Application of David Kirk to rezone property from NS (Neighborhood Shopping) District to C-1 (Local Commercial) District to allow for development of a new drive-through restaurant, at 3795 North Druid Hills Road.

PETITION NO: D6. Z-21-1244885 (2021-2638)

STAFF ANALYSIS

Case No.: Z-21-1244885 **Agenda #:** D6

PRELIMINARY SITE PLAN

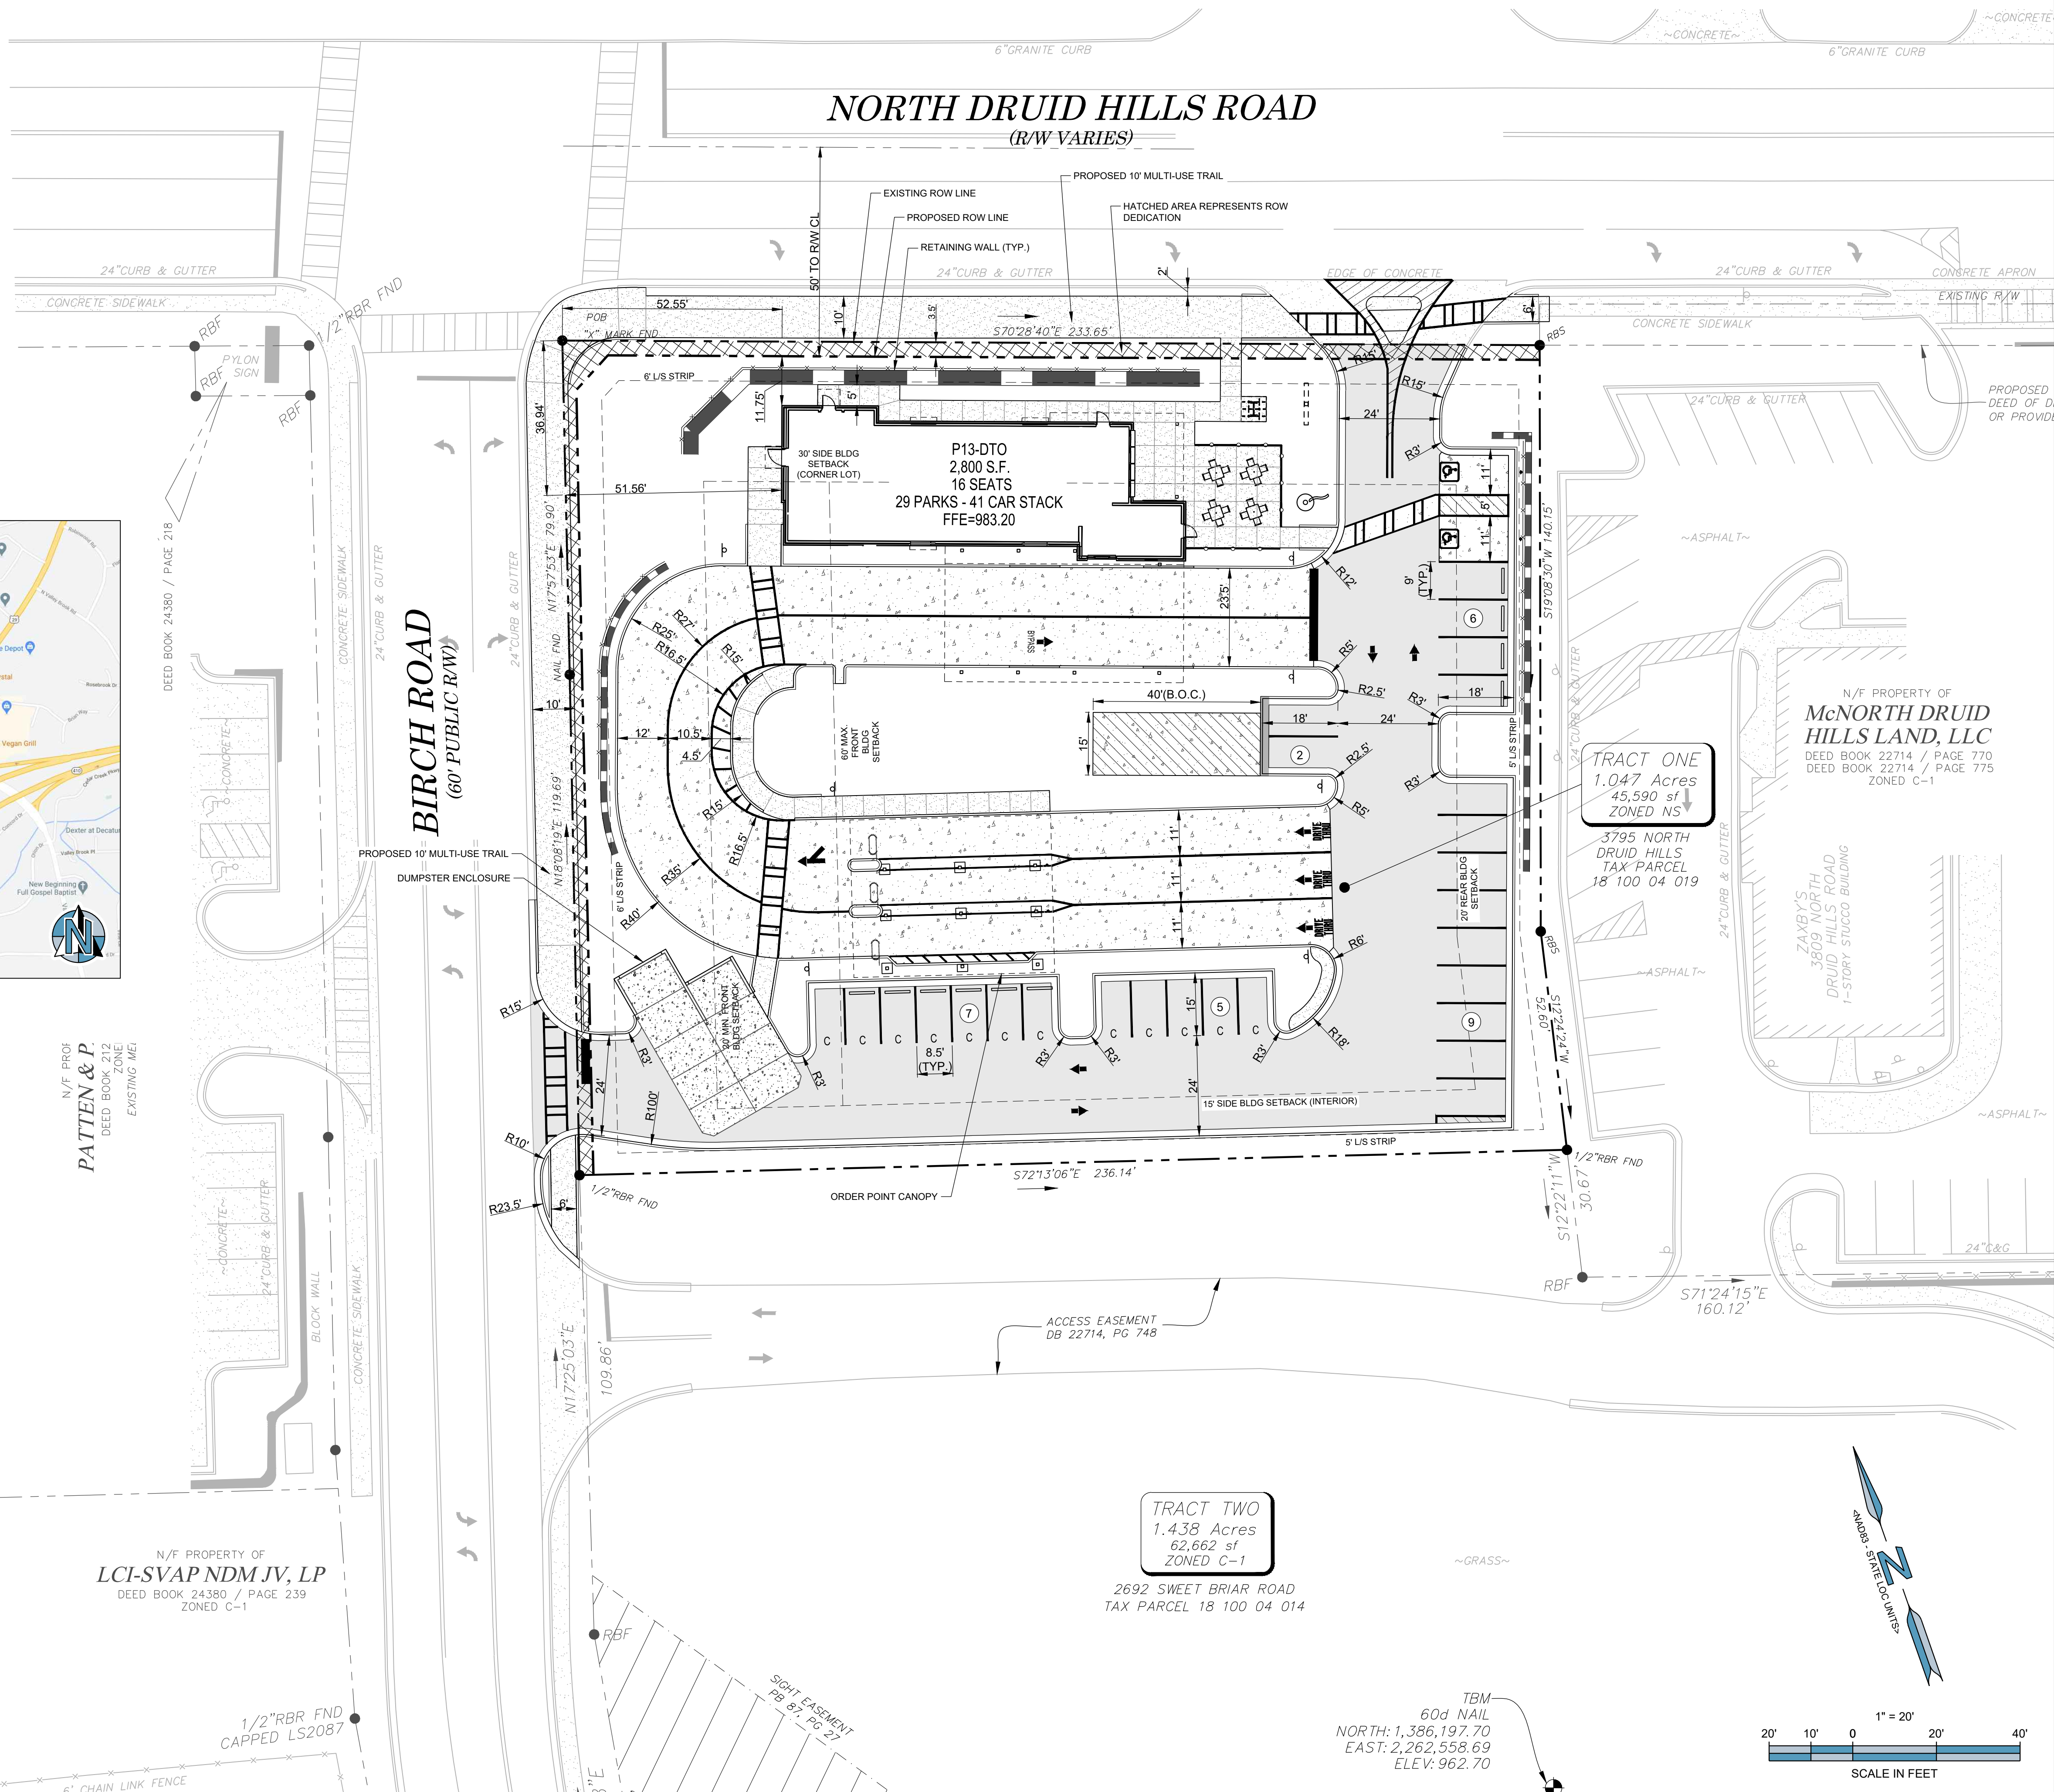
N1 & N2 (Z-21-1244885 & SLUP-21-1244886) - North Druid Hills is classified as a major arterial. Required to add a left turn lane onto Birch. Drive on North Druid Hills limited to Right in/right out only. Please see chapter 5 of the zoning code and chapter 14-190 of the land development code for infrastructure requirements. Requires 10 foot landscape strip, bike lanes and 6 foot sidewalks or 10 foot multiuse path (preferred), street lighting on back of sidewalk. Right of way dedication of 50 feet from centerline or such that all public infrastructure is within county right of way, whichever greater. Birch Road is classified as a local street. Requires a 27.5 foot right of way dedication from the centerline or such that all public infrastructure is on county right of way. Due to the proximity of the mall, potential for redevelopment and connectivity the residential areas- a 10 foot multiuse trail to be included in the sight design along Birch. Requires a 6 foot landscape strip. Streetlights required on back of path.
